Access Compliance Report

Public Rights-of-Way

Intersection ID: 28055	Main Street: STRATHMOOR_DR	Cross Street: PROVIDENCE_RD_WEST	Location: NW
ADA ID: D02C15B236D6	Ramp Type: Perp	Initial Pass/Fail: Fail	Overall Compliance: No
Severity Score: 25			
Codes/Mitigation Info/Possible Solution		Field Measurements/Component Compliance

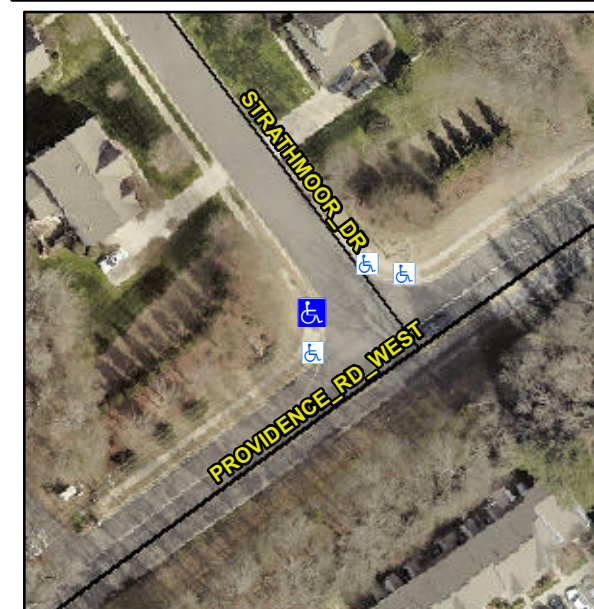
Not Found, R304.2.2, R304.5.3

Compliance	Description	Data	Compliance	Description	Data
N/A	Ramp Length (in)	49.0	No	Ramp Slope (%)	11.4
Yes	Ramp Width (in)	48.0	No	Ramp XSlope (%)	6.2
N/A	Flare Type LT	N/A	N/A	Flare Type RT	N/A
N/A	Flare Slope LT (%)	N/A	N/A	Flare Slope RT (%)	N/A
N/A	Flare Traversable LT?	N/A	N/A	Flare Traversable RT?	N/A
N/A	Landing Length (in)	N/A	N/A	DWS Provided?	N/A
N/A	Landing Width (in)	N/A	N/A	DWS Contrast?	N/A
N/A	Landing Slope (%)	N/A	N/A	DWS Length (in)	N/A
N/A	Landing X Slope (%)	N/A	N/A	DWS Full Width?	N/A
N/A	Landing Curb? (Y/N)	N/A	N/A	DWS Offset (in)	N/A
N/A	Shared Landing?	N/A			
N/A	Gutter Ponding?	N/A	N/A	Gutter Slope (%)	N/A
N/A	Gutter Lip Ht (in)	N/A	N/A	Gutter X Slope (%)	N/A
N/A	Painted X Walk1?	No	N/A	Painted X Walk2?	N/A
	X Walk 1 Direction	To NE		X Walk 2 Direction	N/A
N/A	X Walk 1 Width (in)	N/A	N/A	X Walk 2 Width (in)	N/A
	X Walk 1 Slope (%)	0.8		X Walk 2 Slope (%)	N/A
	X Walk 1 X Slope (%)	4.7		X Walk 2 X Slope (%)	N/A

Remove & Replace Entire Ramp.
